## M4 Junction 28 Improvement Works, Newport, South Wales

### Road Safety Audit Stage 1

## Road Safety Audit Stage 1

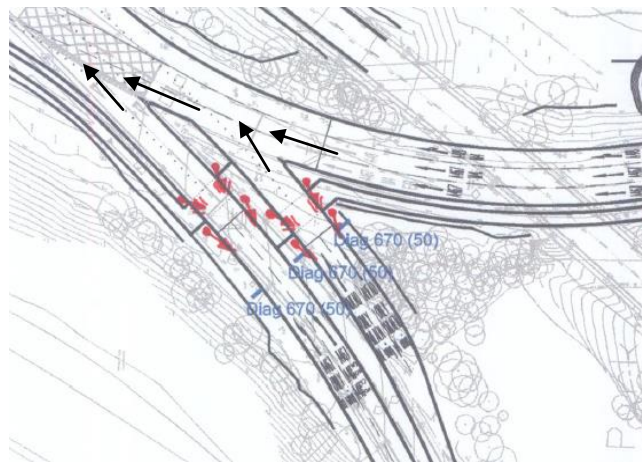
There is a significant amount of vegetation around the existing junction. Poor forward visibility to traffic signal heads and signs due to being obscured by foliage may result in late braking, shunt, side-swipe and overshoot-type vehicle collisions (and also potential vehicle to pedestrian collisions where a crossing is present).

It should be ensured that adequate forward visibility is provided to traffic signal heads and signs throughout the junction which may require the cutting back or removal of vegetation.

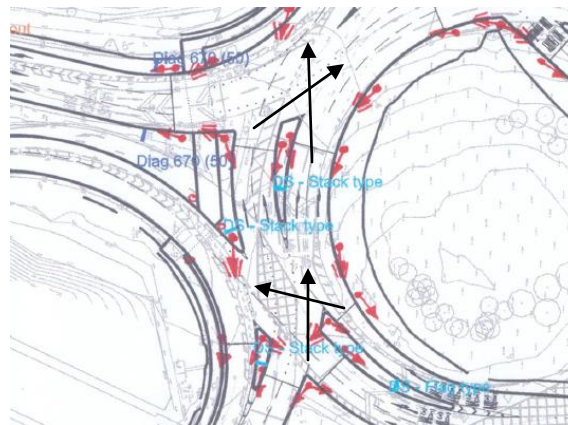
The M4 eastbound exit slip on the north east approach to the circulatory carriageway is shown to have traffic signals but it is not clear if these are purely for the controlled pedestrian crossings or the signals are integrated into the circulatory carriageway phasing and staging.

*In addition, although the drawing shows an adjacent stop line on the circulatory carriageway, no traffic signals are shown. This should be added at detailed design stage.*

It should be clarified at detailed design stage if the approach is to be integrated into the junction signalisation.

*Give way markings to cater for the eventuality of the signals failing.*
